Response to United States Environmental Protection Agency Request dated March 8, 2018 on the Back Forty Project Wetland Permit Application

Submittal No. 2NN-5PE0-MT3W USEPA Reference No. WW-16J

Project I.D.: 17A021.18

Re: Response to USEPA March 8, 2018 Comment Letter

Attachment 3.2 Wetland Monitoring Plan Figures

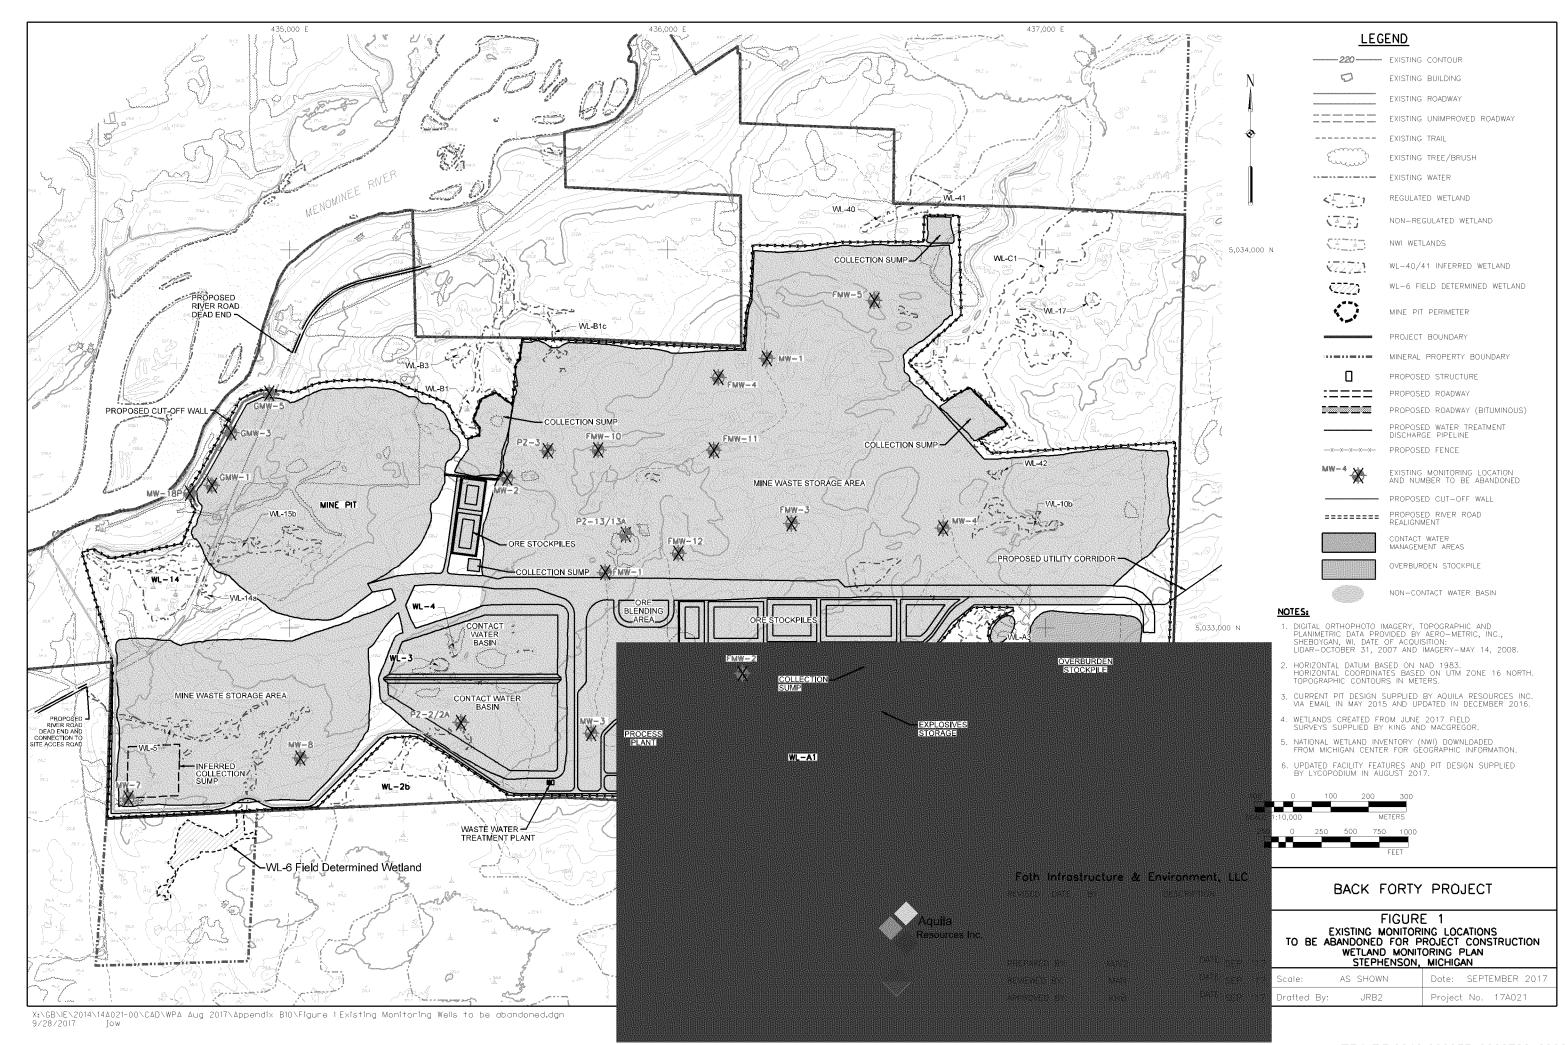
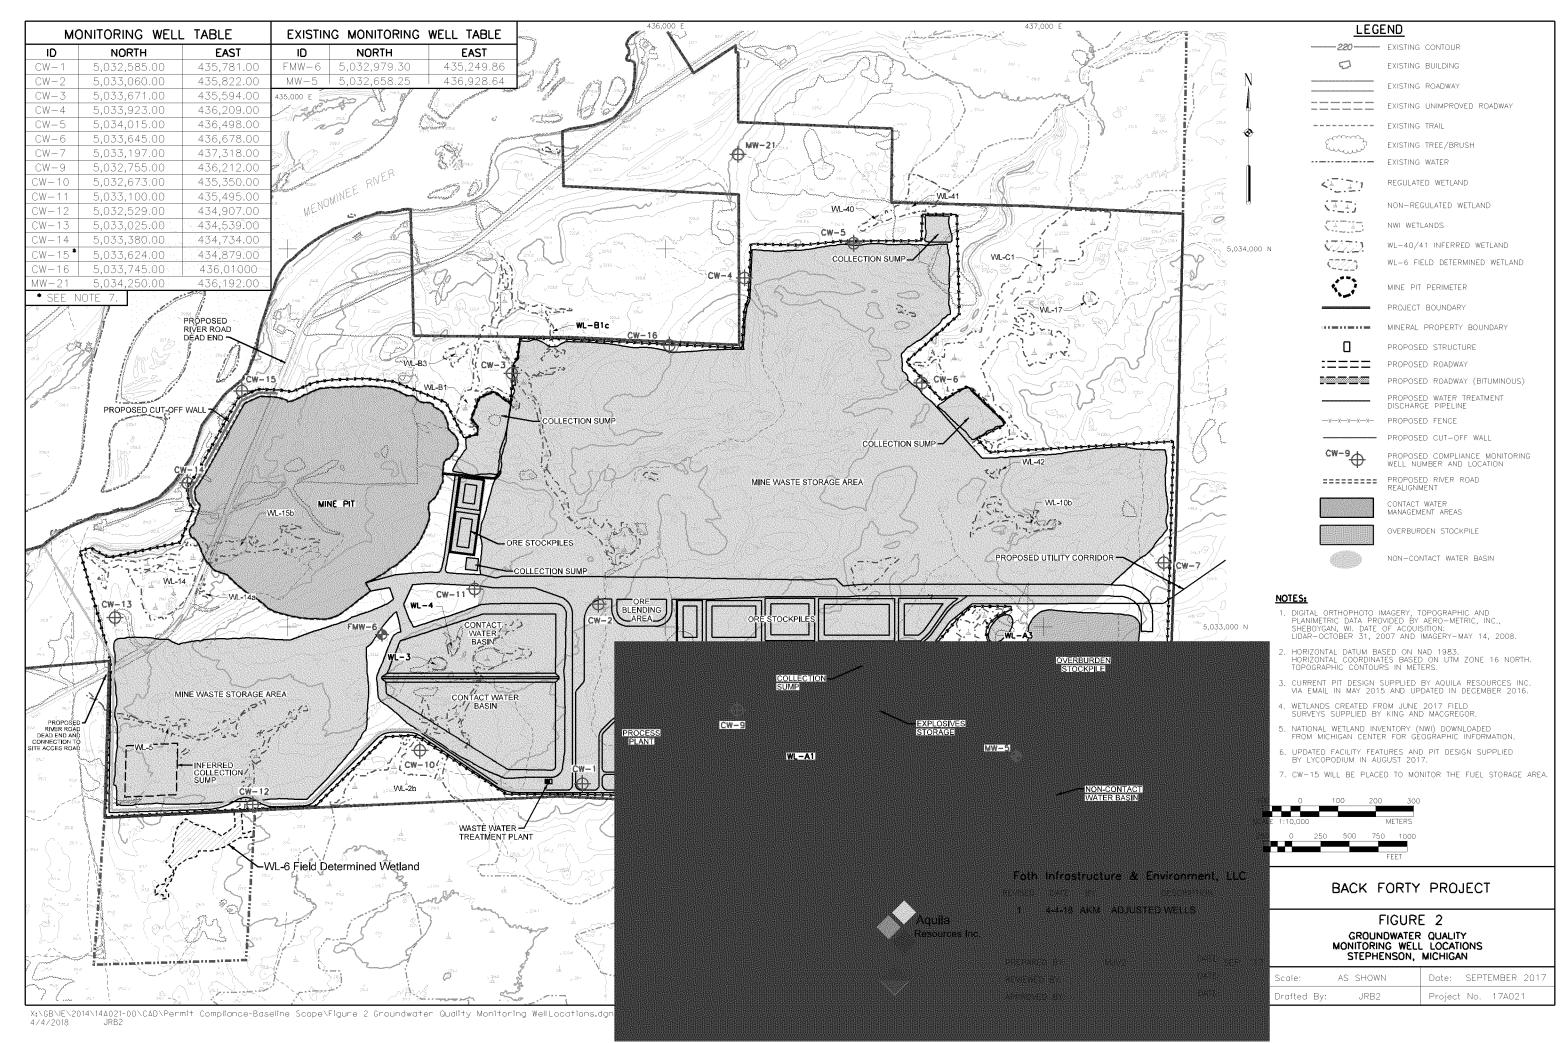
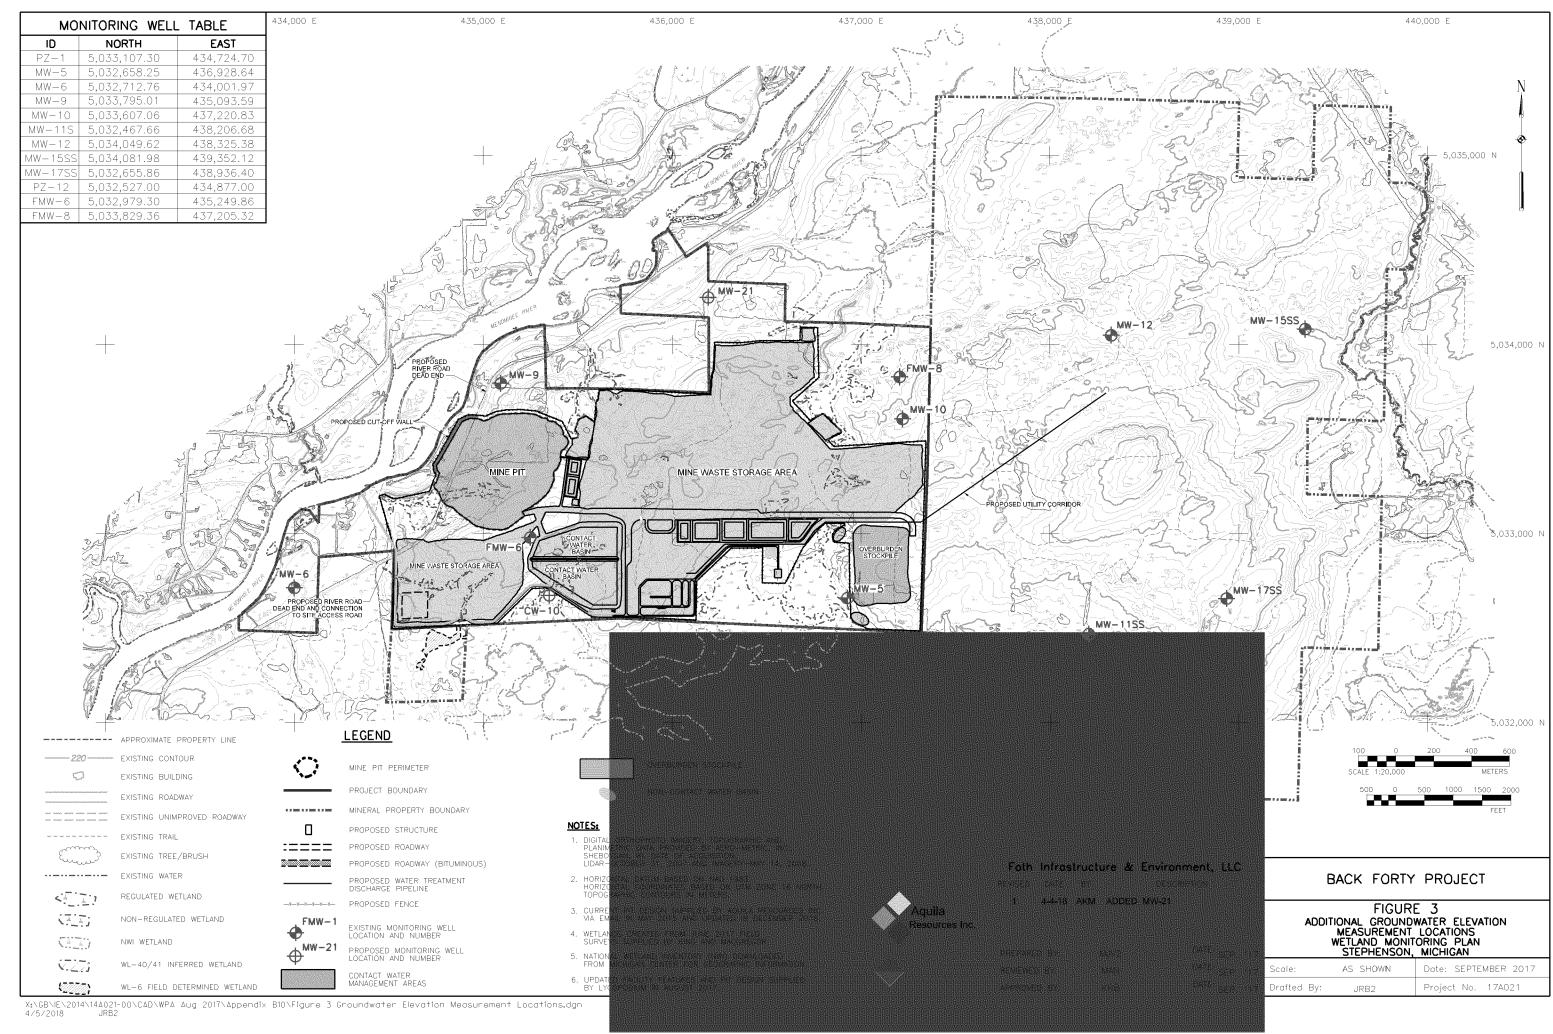
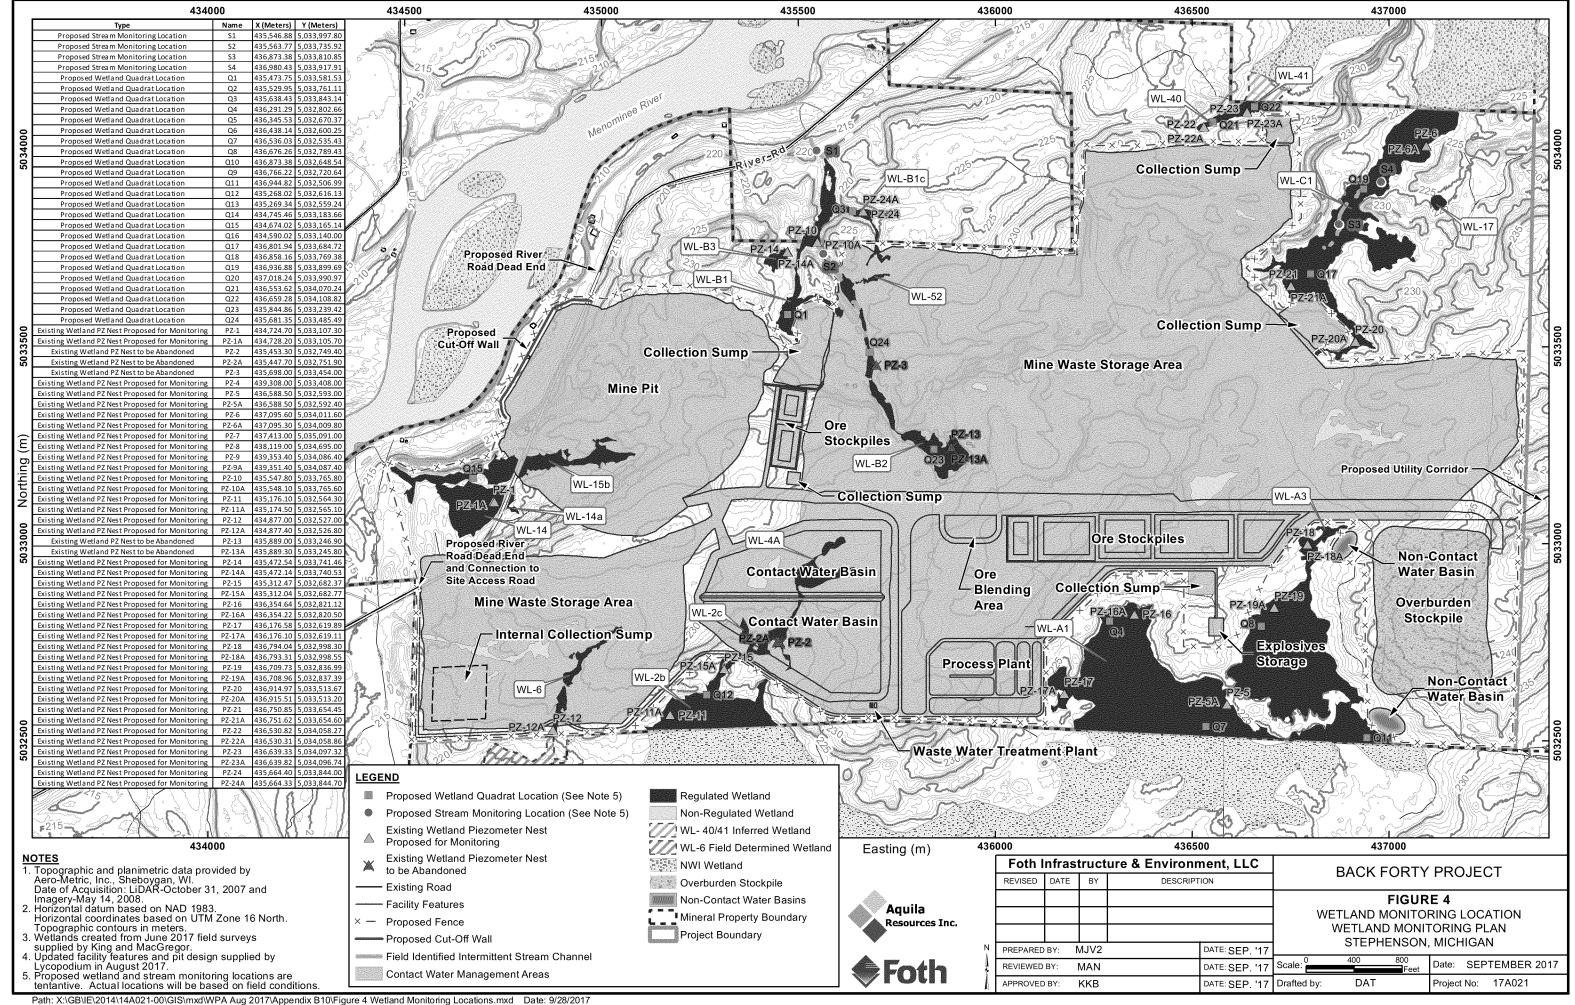
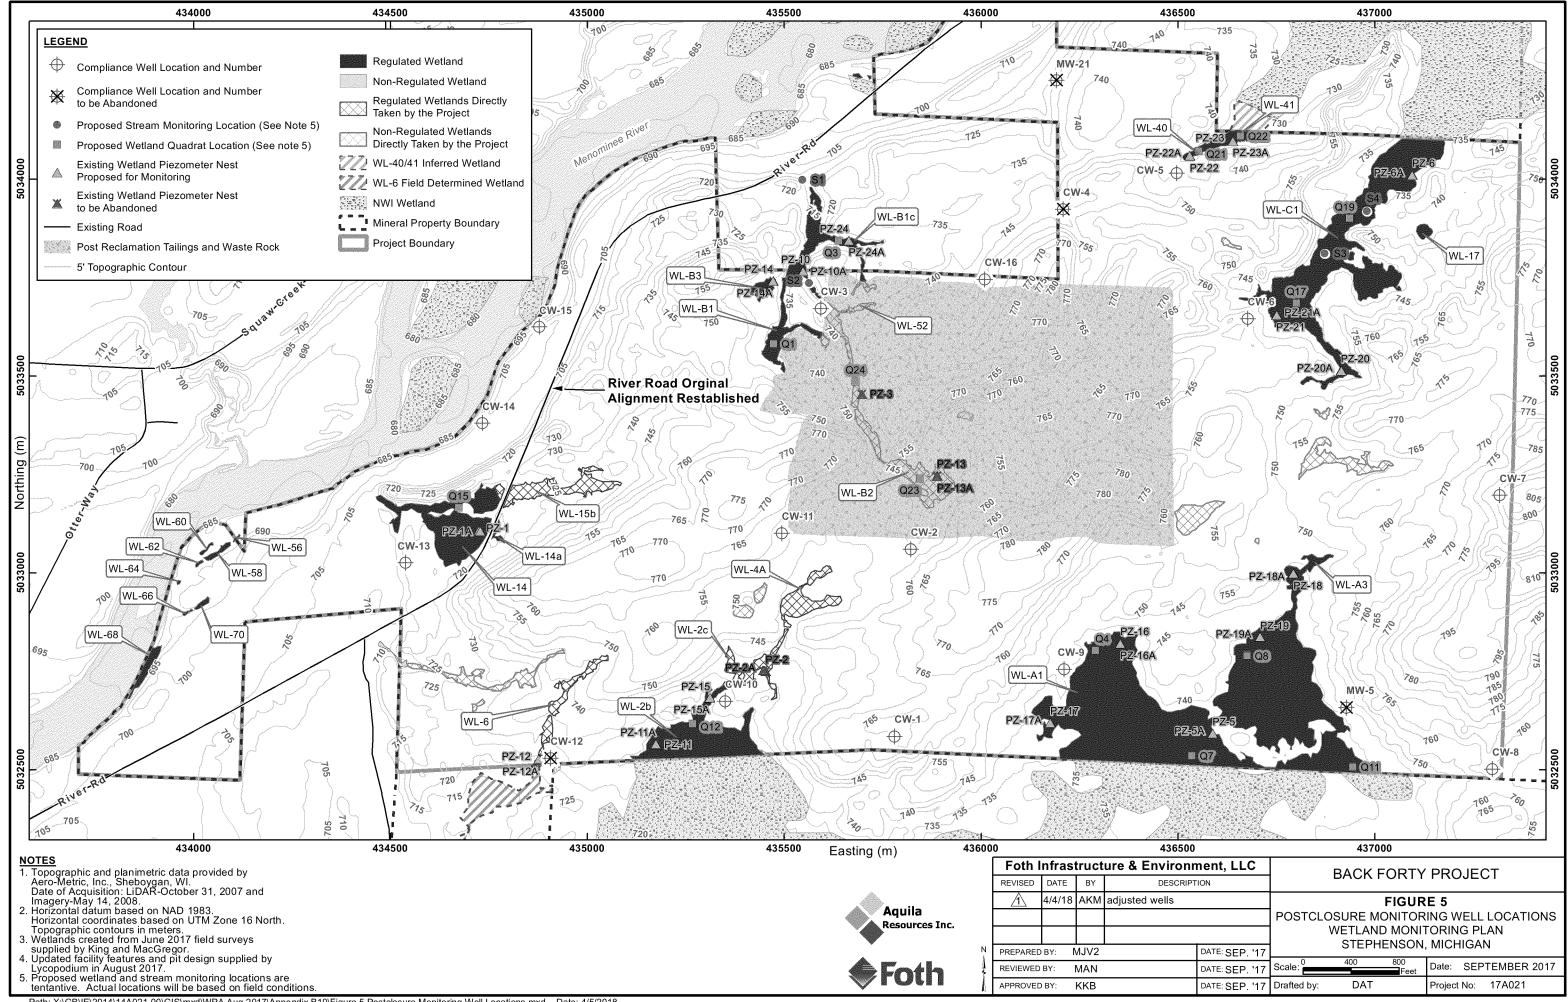
Provide additional details regarding monitoring, impact criteria, and specific adaptive management mechanisms sufficient to demonstrate avoidance and minimization of impacts to aquatic resources and prevention of contamination and unanticipated discharges.

Surface water and groundwater monitoring have been addressed in the Mining Permit and the NPDES Permit. The surface water monitoring locations and parameter list are provided in the NPDES Permit Fact Sheet, Attachment 3.1. Groundwater monitoring wells serving the updated facility appear in Appendix B-10 of the Application and are presented in Attachment 3.2:

Figure 1 – Existing Monitoring Locations to be Abandoned for Project Construction

Figure 2 – Groundwater Quality Monitoring Well Locations (revised)

Figure 3 – Additional Groundwater Elevation Measurement Locations (revised)

Figure 4 – Wetland Monitoring Locations

Figure 5 – Postclosure Monitoring Well Locations (revised)
